**MEETING NOTICE AND AGENDA**  
**TECHNICAL ADVISORY COMMITTEE**  
**OF THE**  
**SEASIDE BASIN WATER MASTER**

**DATE: Wednesday, January 13, 2016**

**Seaside Groundwater Basin Watermaster  
Technical Advisory Committee Meeting  
November 18, 2015**

Subject: Groundwater Flow Divides within and East of the Laguna Seca  
Subarea

Figure 2: Groundwater Elevations and Flow Divides – Historic Scenario, February 2010

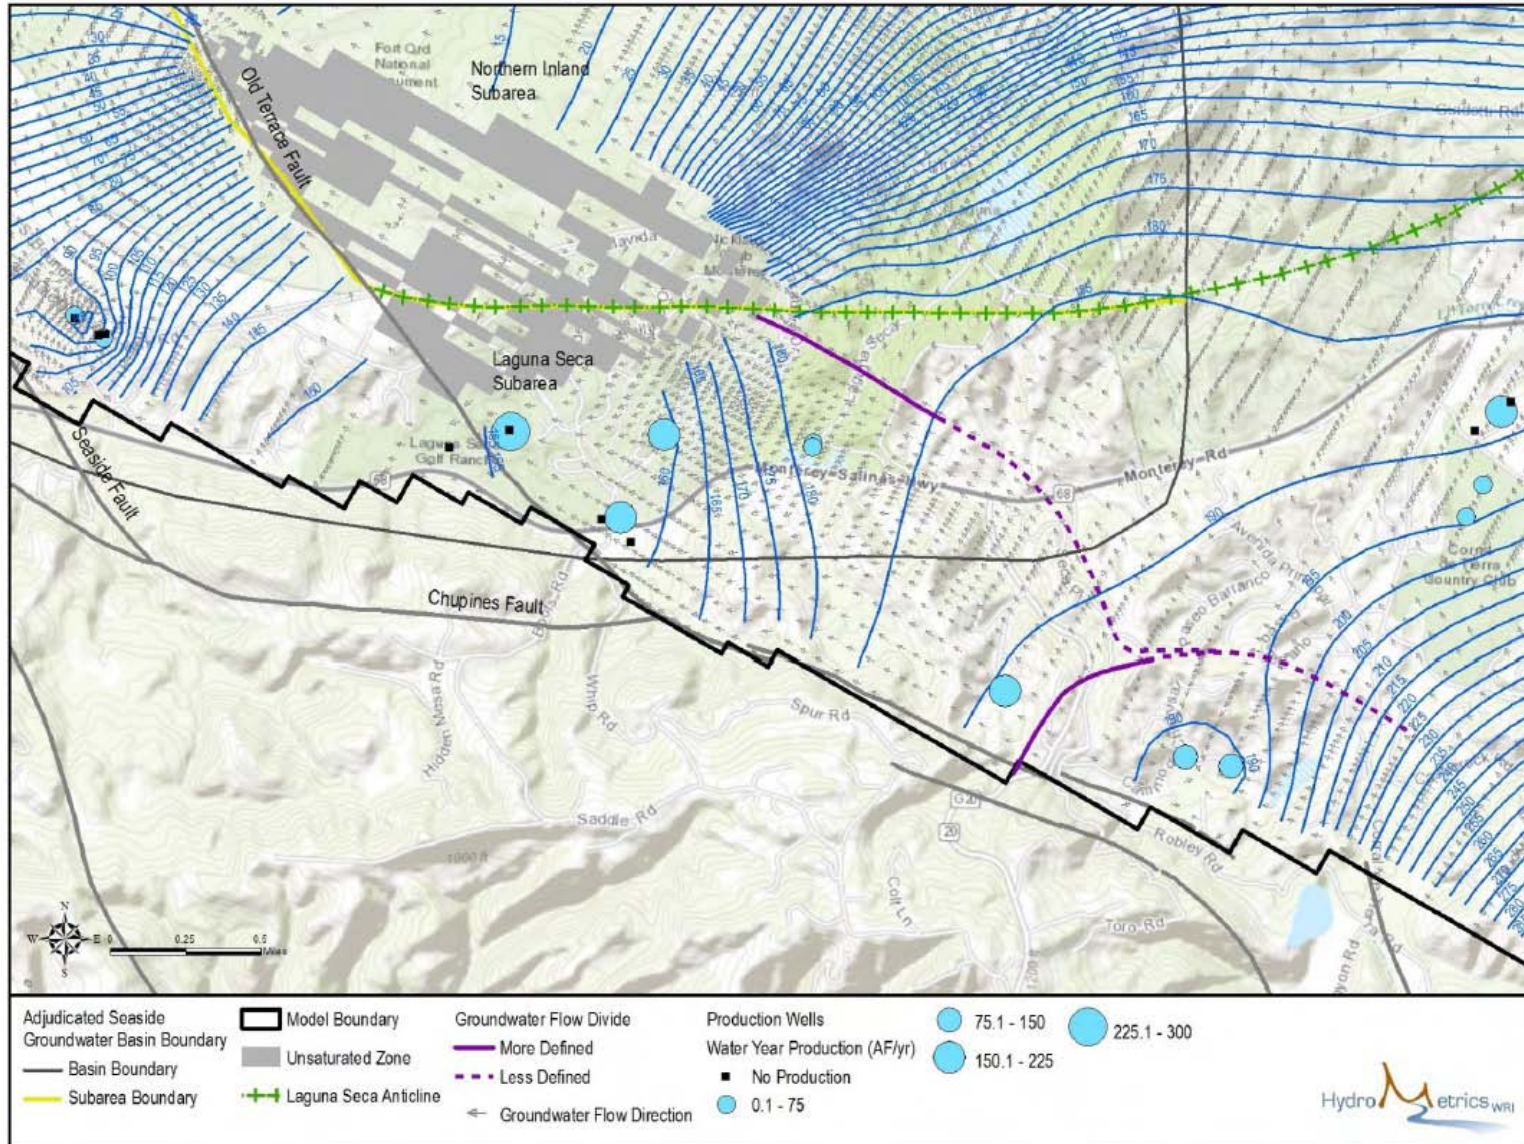
Mr. Jaques commented that Figure 1 in the earlier draft version of the report had shown somewhat different groundwater flow paths than the figure shown in the PowerPoint slides. Following some discussion Mr. Oliver and Ms. King expressed the feeling that the PowerPoint figure more correctly showed the flow paths than the earlier draft version of that figure.
